**Short-term concept design and costing - Clifton to Tangoio 2120  
coastal strategy - Design workstream**  
Flood defences Pandora Unit

Hawkes Bay Regional Council Publication No. 5588

Peer Reviewed By:

## Revetment 1 (Pandora)

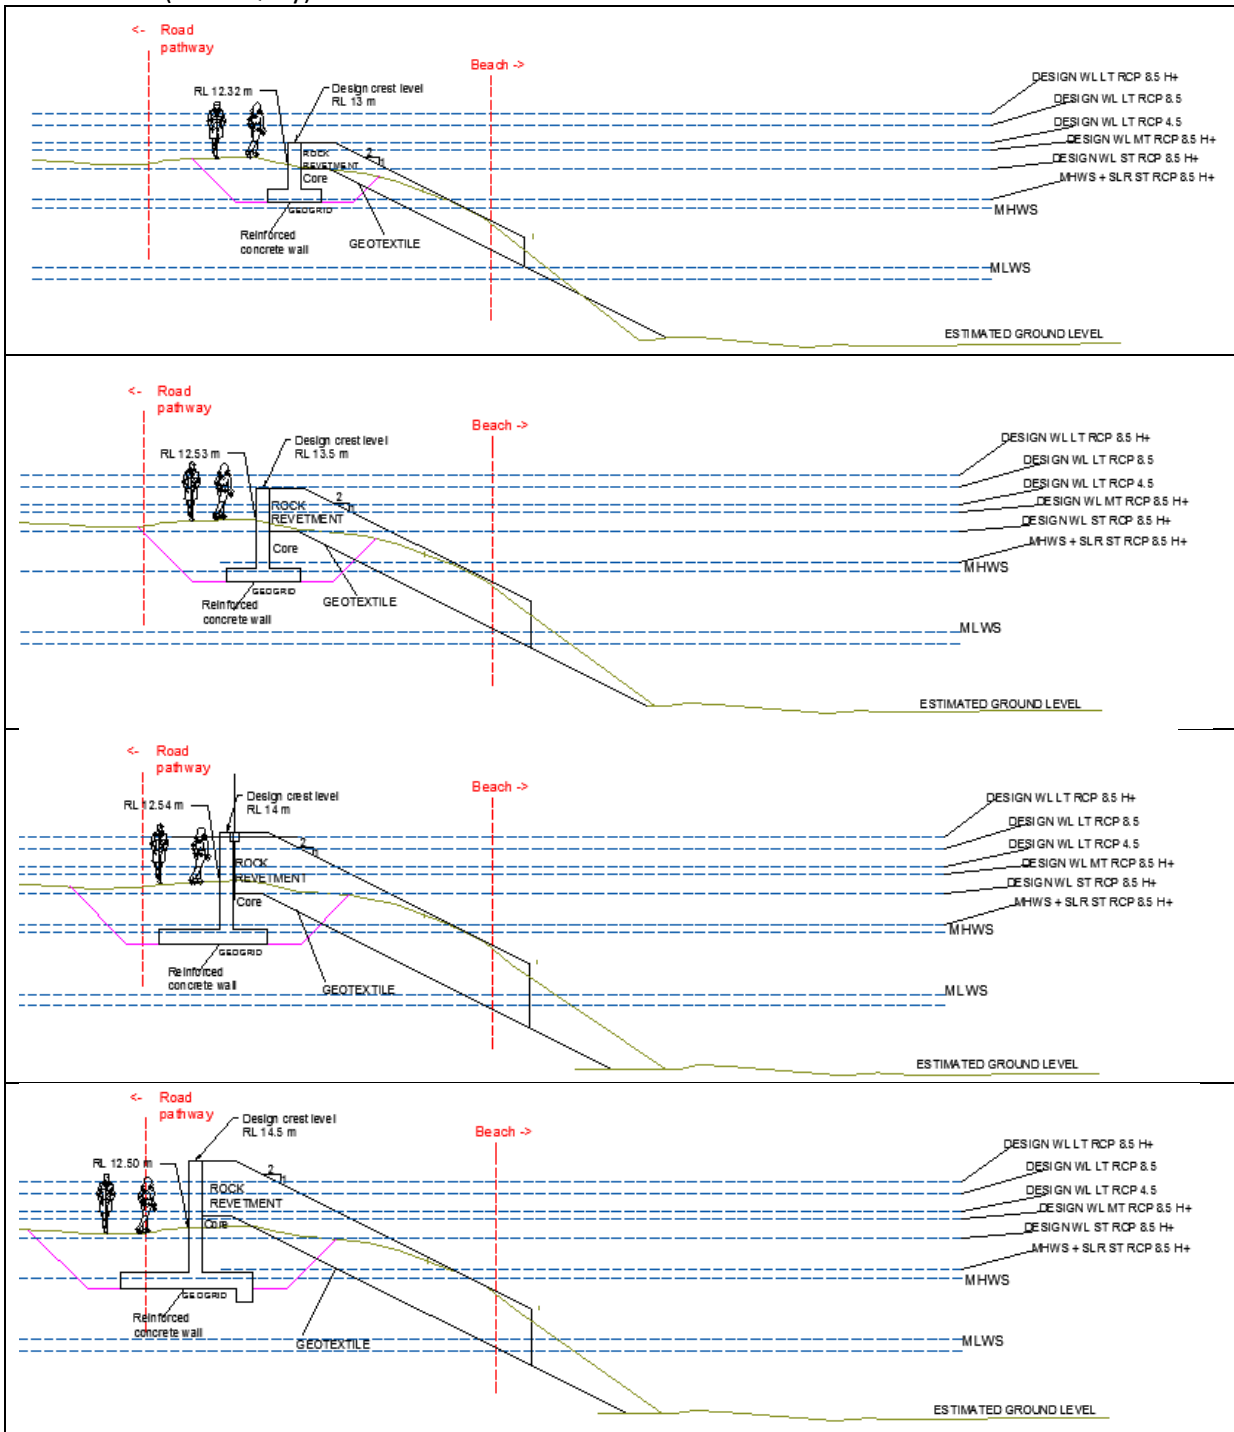
5.4	<p><b>Toe protection</b> – The design of the falling toe for protection against scour/erosion is considered over designed for the environment and the relative size of the revetment 1 (Figure 5.4-A). Given the toe of the structure is somewhat higher than MLWS at the time of construction it would be more practical to excavate and embed the toe of the revetment into the existing land, which would also reduce the structure footprint and occupation within the estuary. The rock revetment is also not critical to preventing flooding which is for the most part governed by the concrete wall. Consequently, the revetment design can accommodate a higher level of tolerable damage.</p> <p>Figure 5.4: Example drawing from report of cantilever wall and rock revetment 1 (p.28)</p>	November 2021	See response to comment 3.4	21-03-2022	Y
